HOMESTEAD NORTH AT STERLING RANCH FILING NO.3

STREET IMPROVEMENT PLAN

HOMESTEAD NORTH AT STERLING RANCH FILING NO.3
COUNTY OF EL PASO, STATE OF COLORADO
STORM & POND PLANS

STORM PLANS

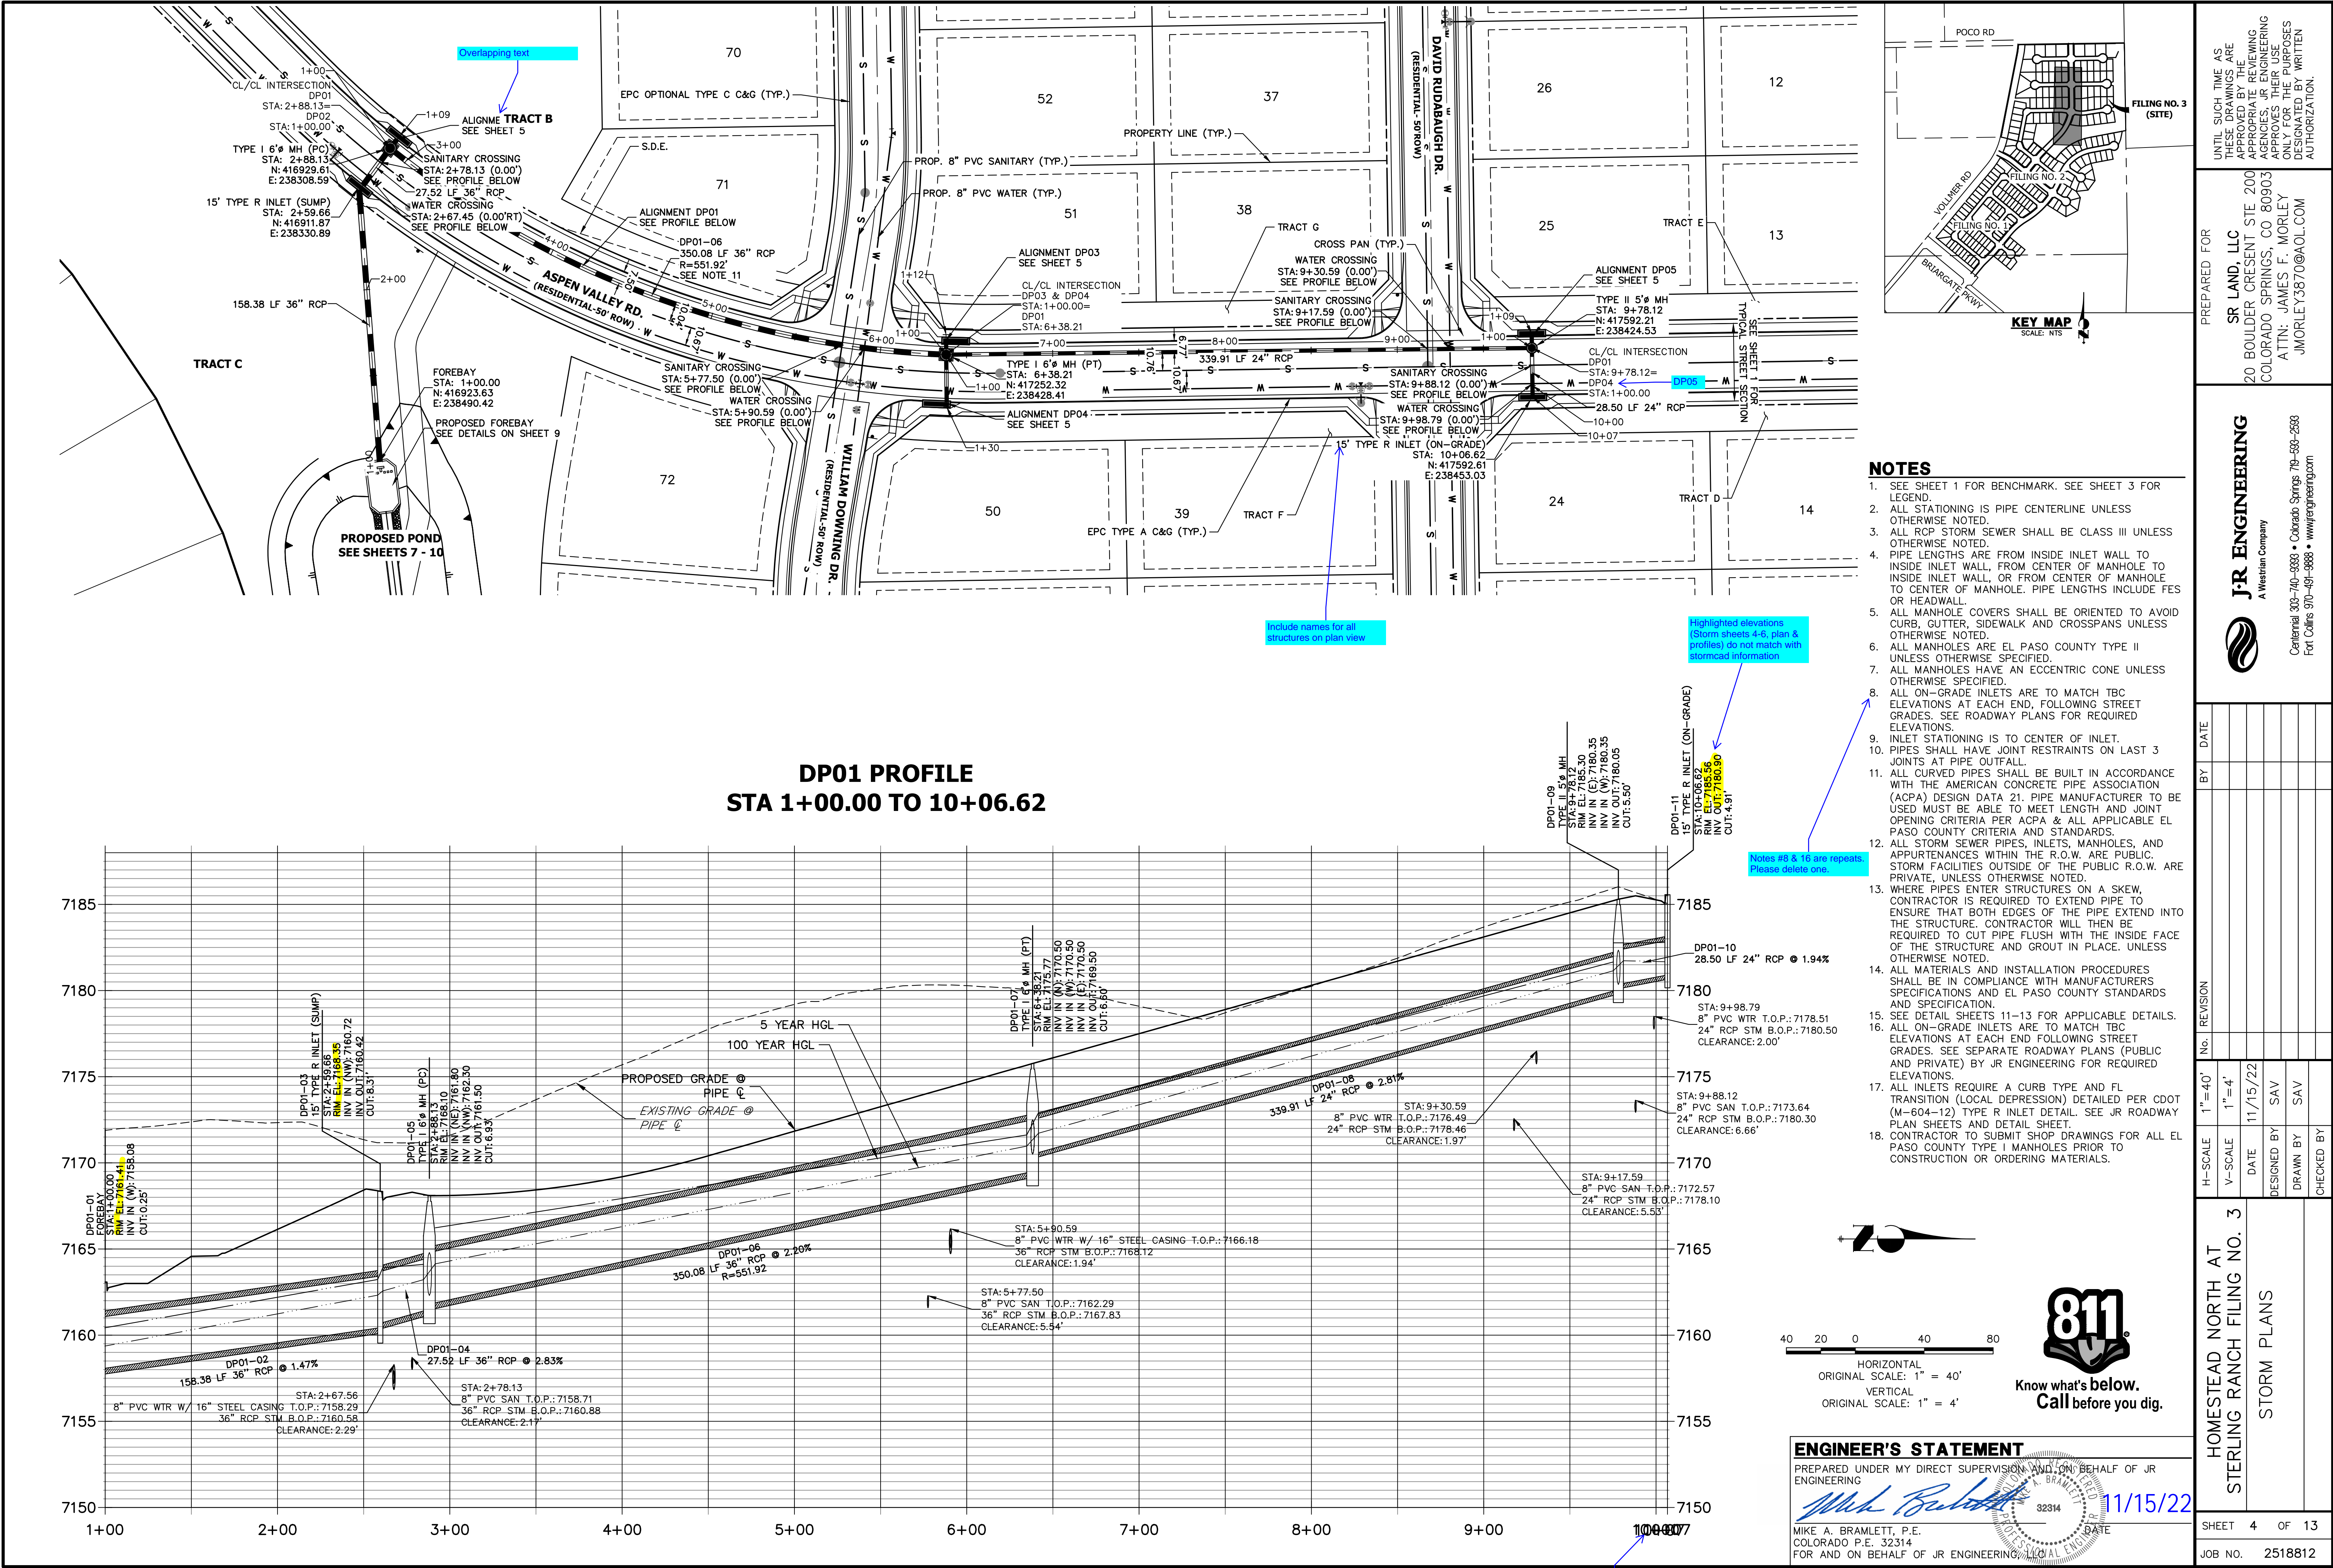
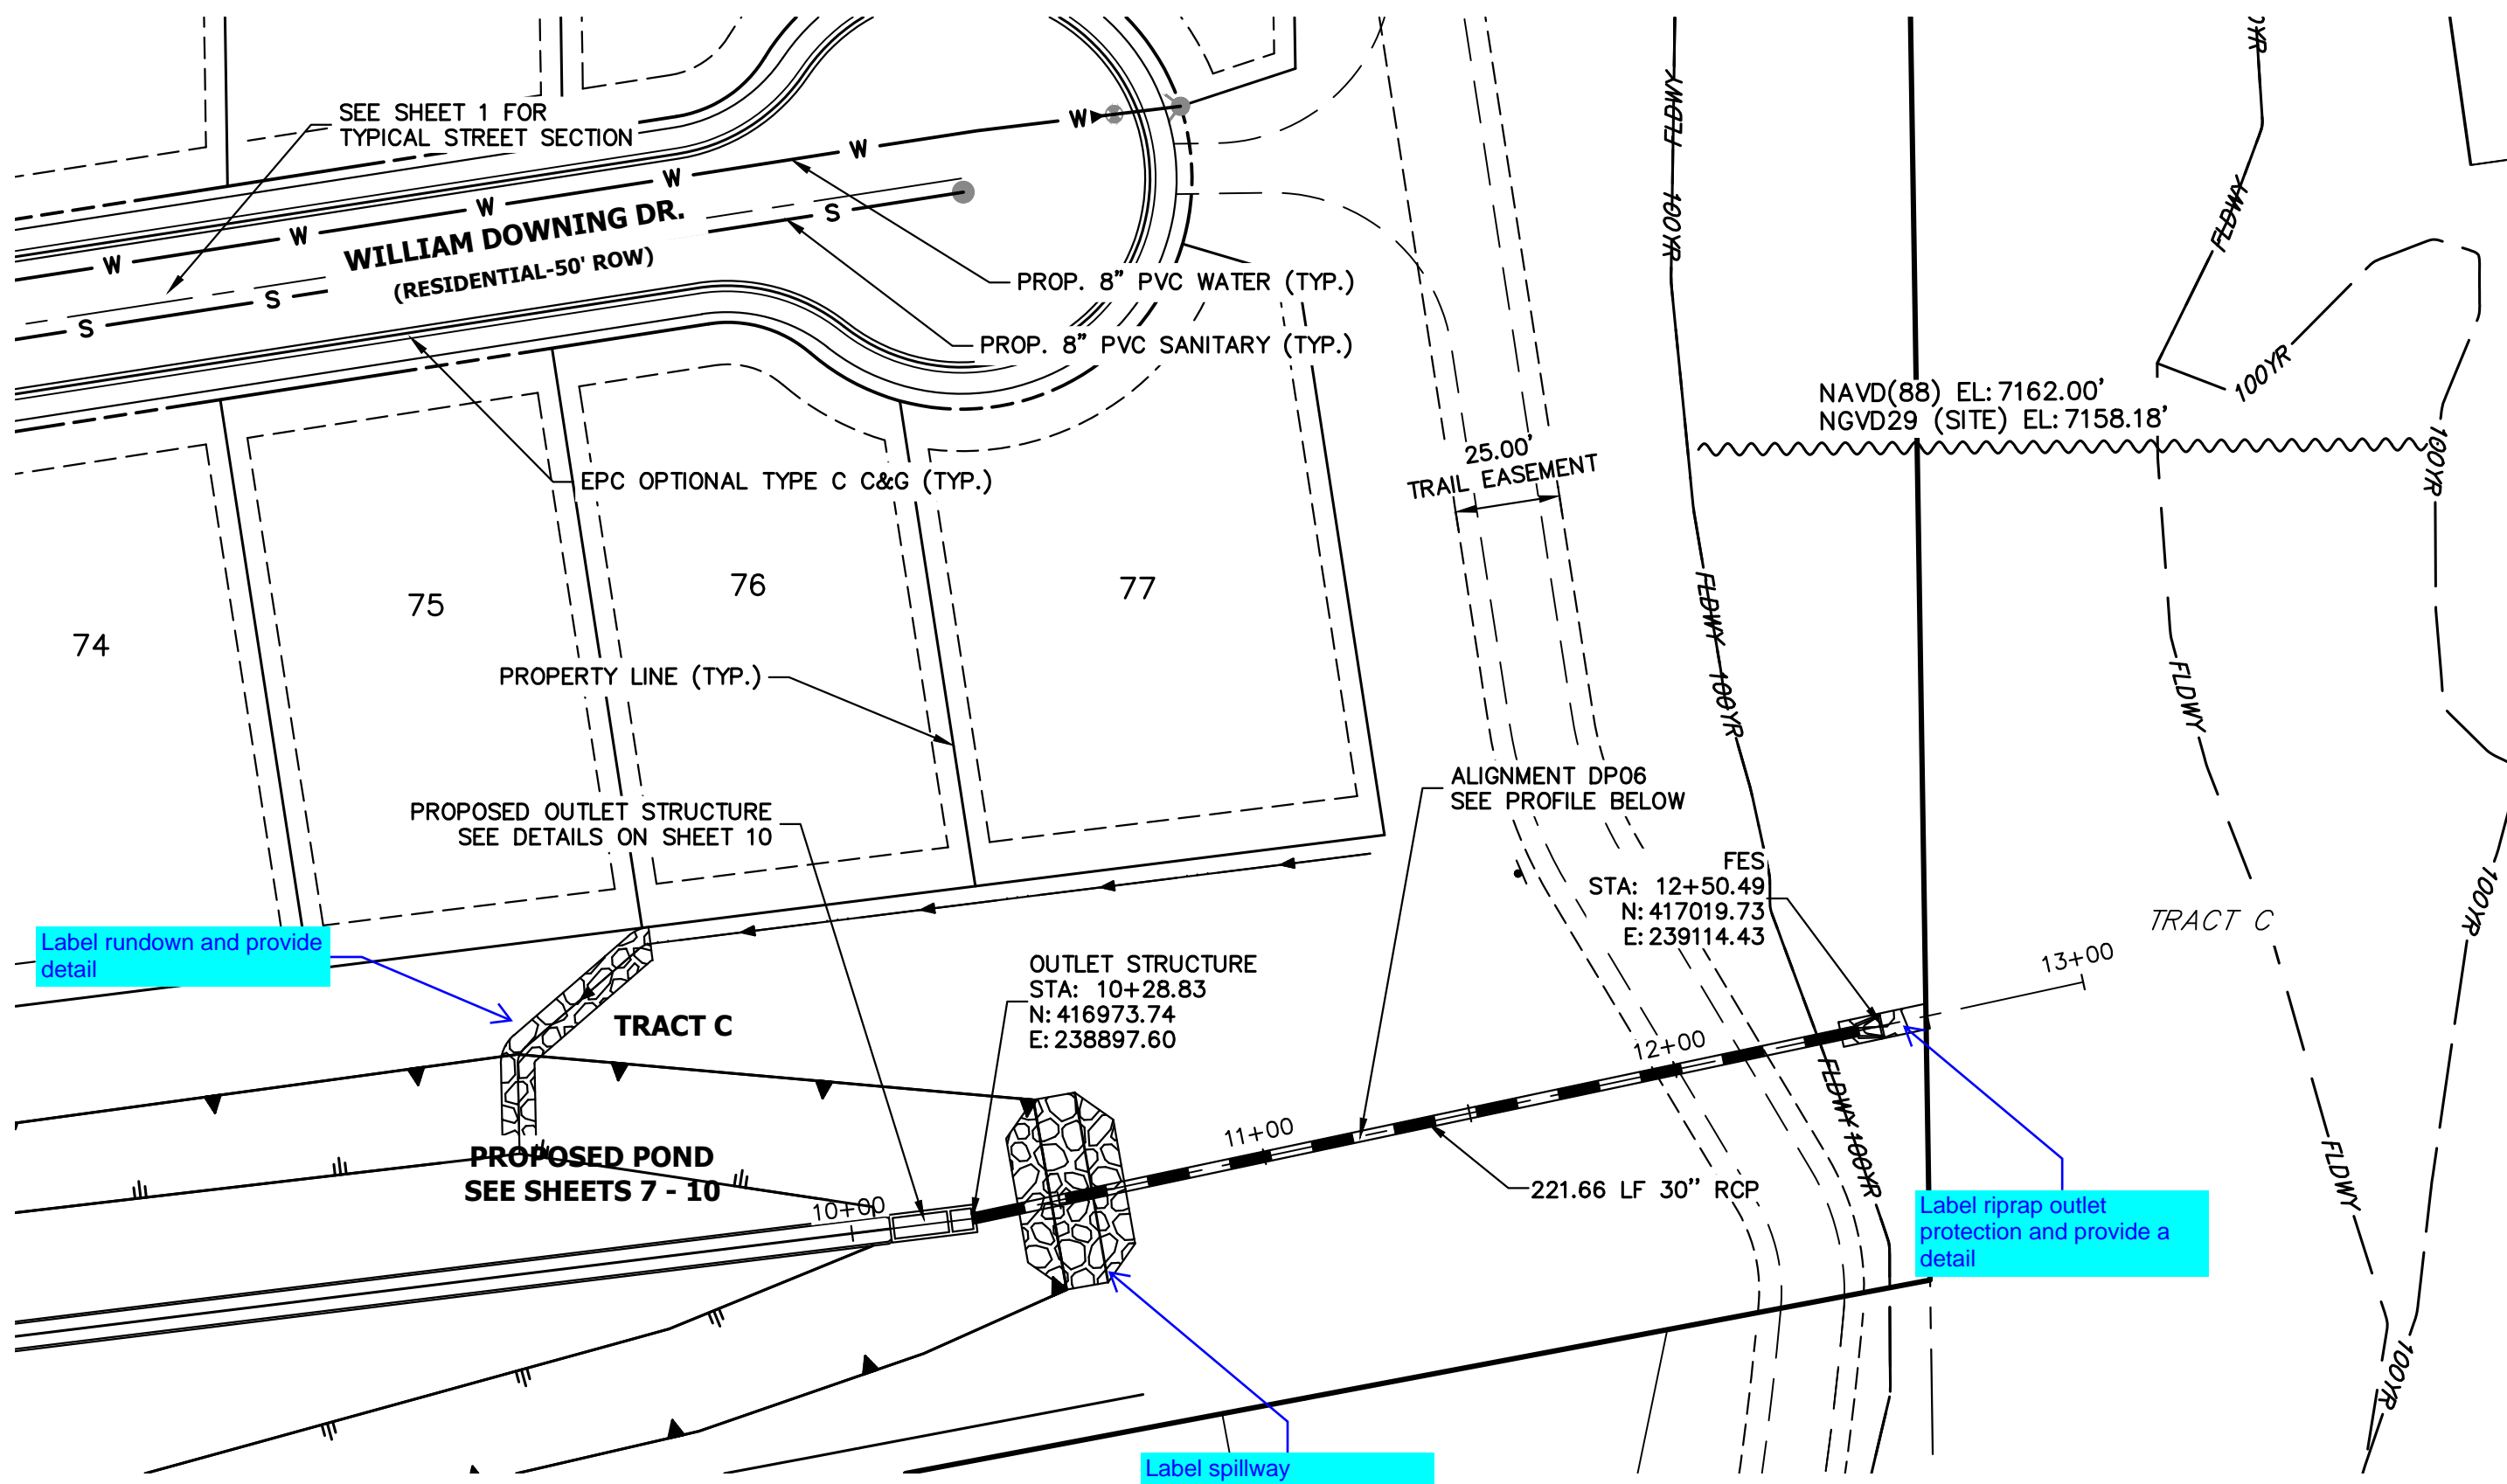
Show & label riprap outlet protection

Highlighted elevations (Storm sheets 4-6, plan & profiles) do not match with stormcad information
